# ADDENDUM ONE

Project: **Sullivan County Miller Perry Elementary School Reroof**

February 28, 2023

This Addendum is part of the Contract Documents for the above referenced project and modifies the original drawings and/or specifications, dated **2/13/23**, as noted below. The bidder shall acknowledge receipt of this Addendum in the place provided in the Bid Form. The published bid date and time shall remain the same.

G-01

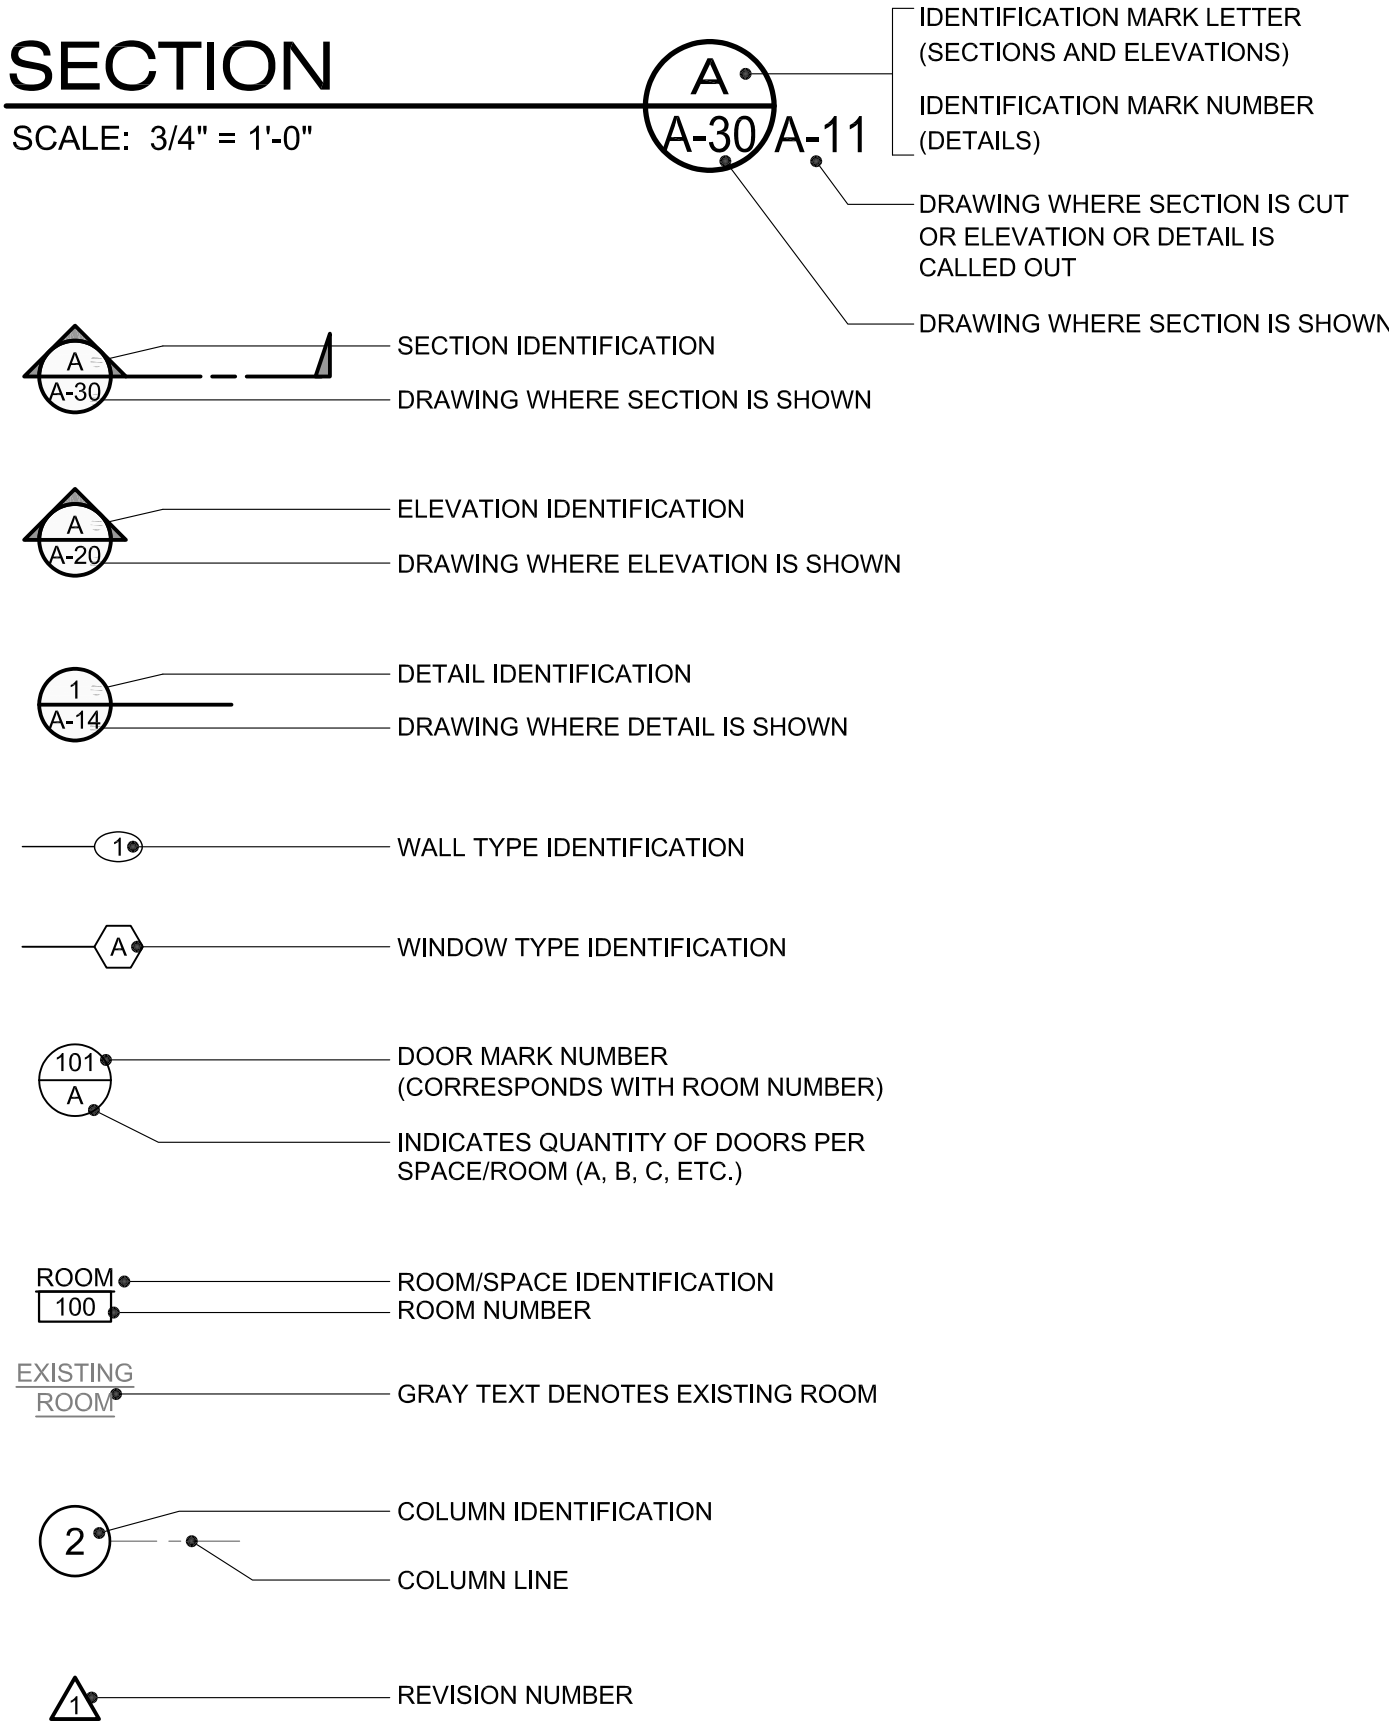
**G-01 General Information** – See revised list of alternates.

ADD ALTERNATE #1

REPLACEMENT OF ROOF DRAIN COLLECTORS AND DOWNSPOUTS.

A-15

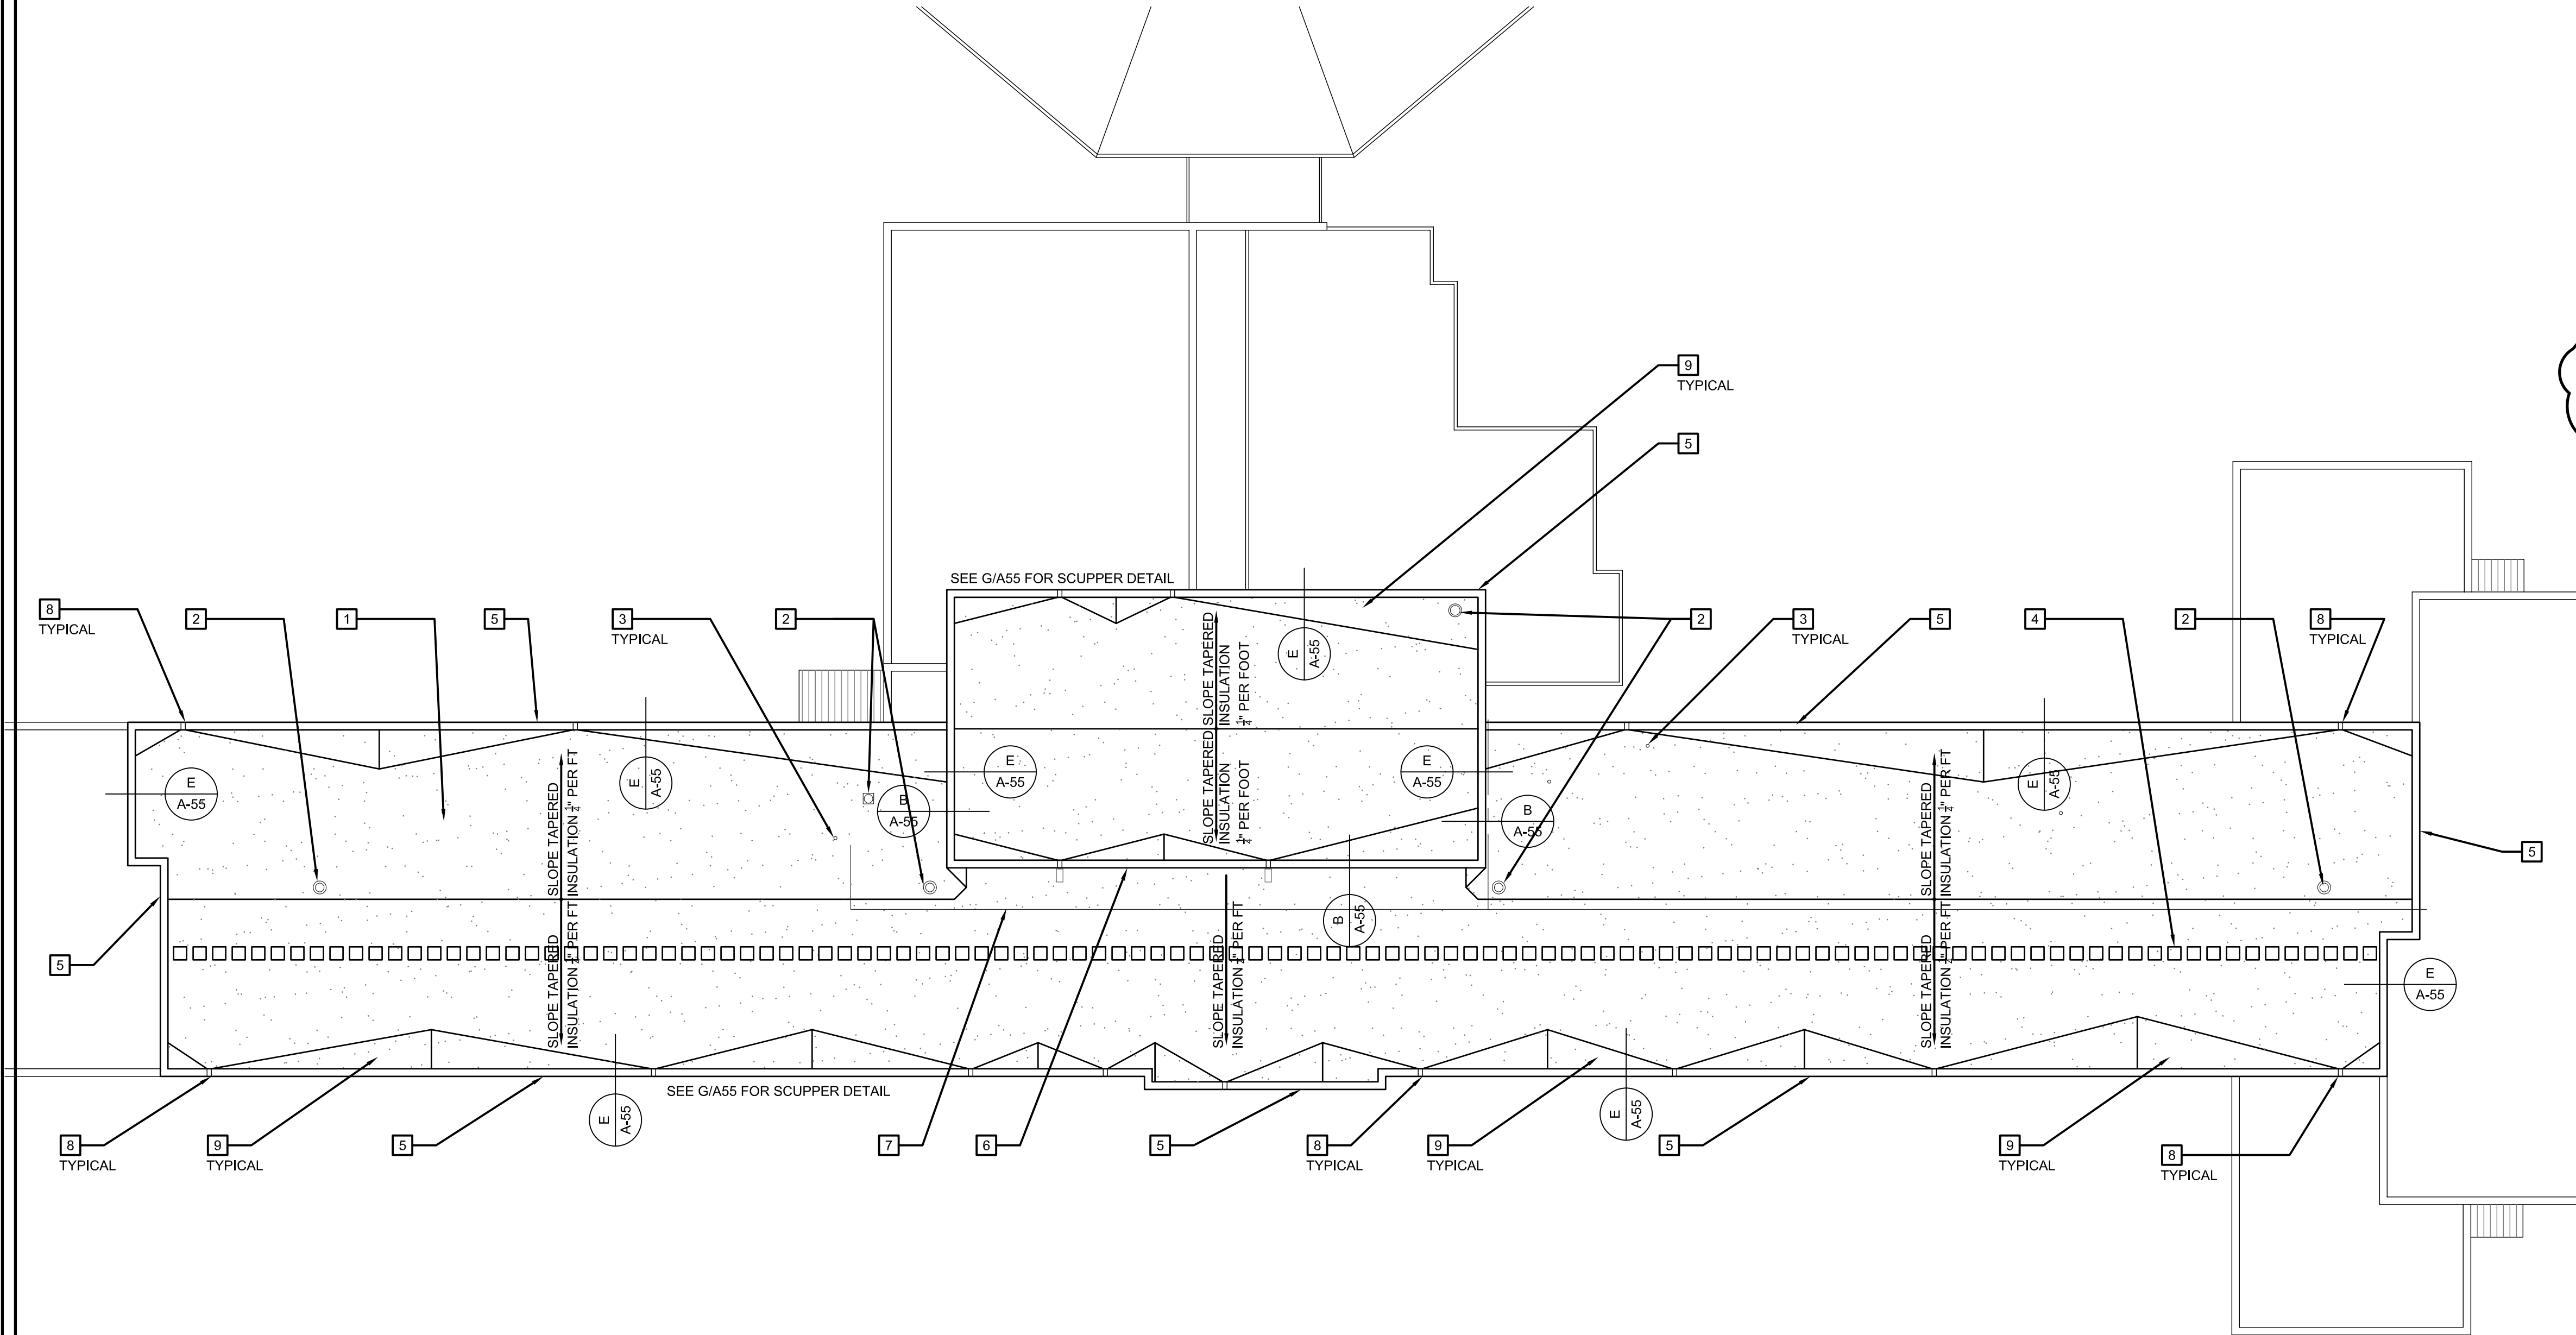
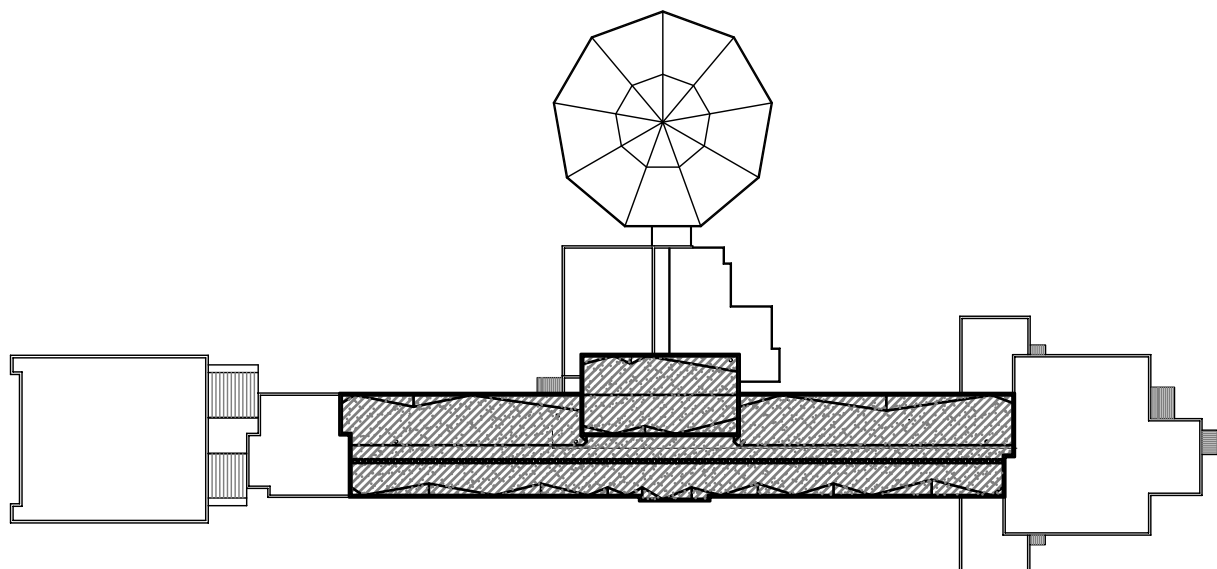
**A-15 Roof Plan** - See revised drawing scale.

**A-15 Roof Plan** - See revision to include new collectors and downspouts at roof scuppers.

ALTERNATE #1:  
 PROVIDE AND INSTALL NEW ROOF DRAIN COLLECTORS AND DOWNSPOUTS AT ALL LOCATIONS OF ROOF SCUPPERS. NEW ITEMS ARE TO MATCH EXISTING MATERIAL, CONFIGURATION AND COLOR OF EXISTING. CONNECT NEW DOWNSPOUTS TO EXISTING STORM DRAINAGE.
